# ADA Curb Ramp New Construction Inspection Form (Perpendicular)

Nw 294th

23885.56

Nw 293rd

## PERPENDICULAR RAMP (PR)

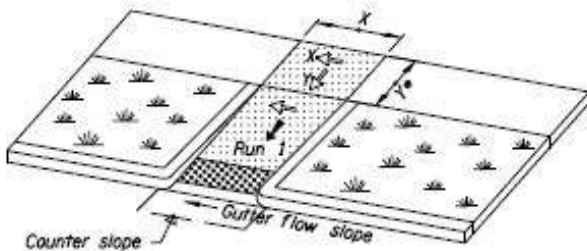
IITD RR 1 Fails
